10 Mb/s Single Twisted Pair Ethernet 10BASE-T1L Receive Watchdog State Diagram

10BASE-T1L Receive Watchdog State Diagram

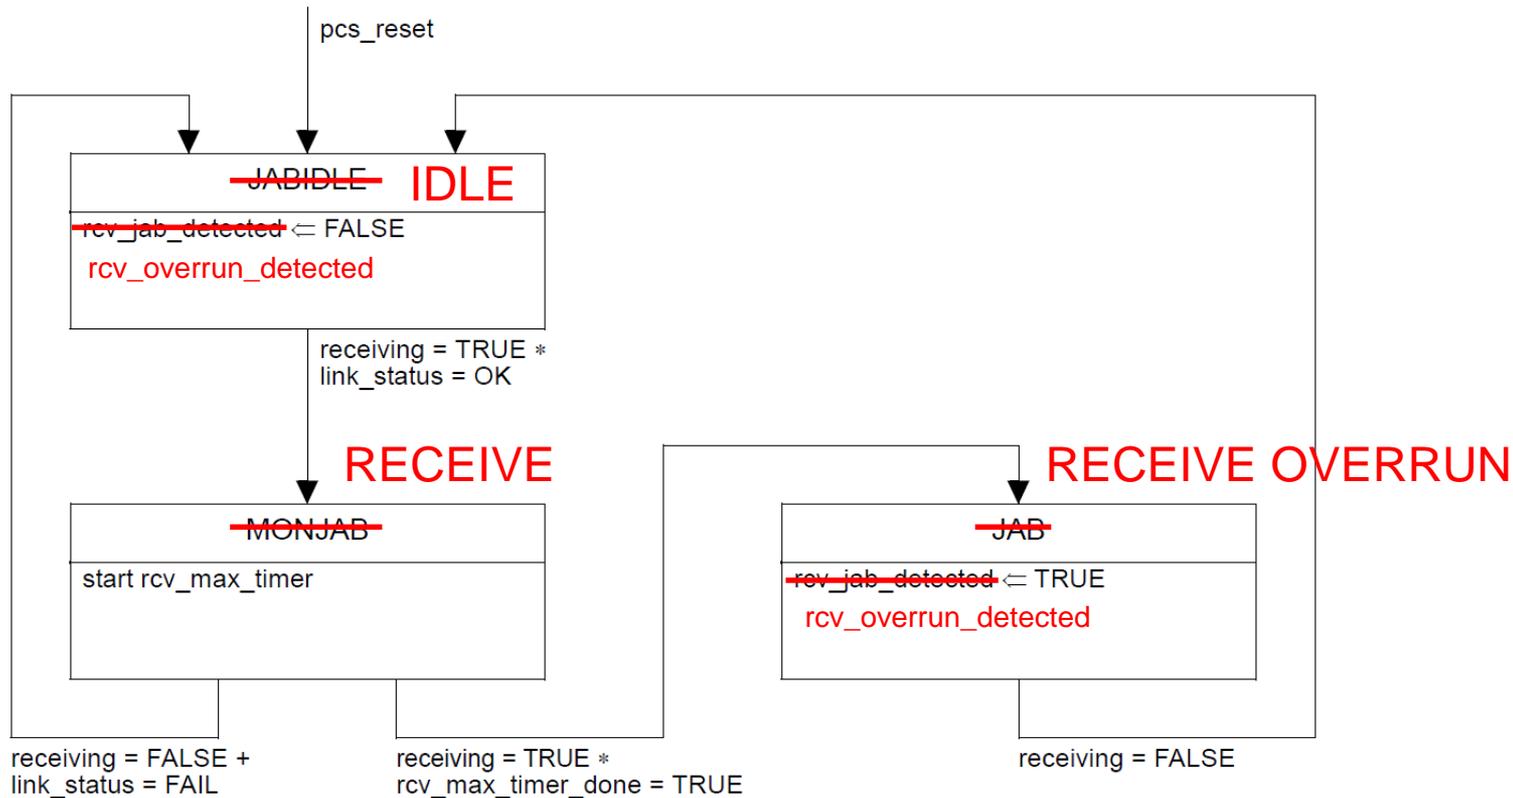
- Add the modifications shown in red to the “Receive Watchdog state diagram” in Figure 146-10.
- Rename variable “`rcv_jab_detected`” to “`rcv_overrun_detected`” in all other occurrences of the standard.
- Change variable description to: Variable set as TRUE when in **RECEIVE OVERRUN** state as shown in Receive watchdog state diagram in Figure 146–10 and set FALSE otherwise.
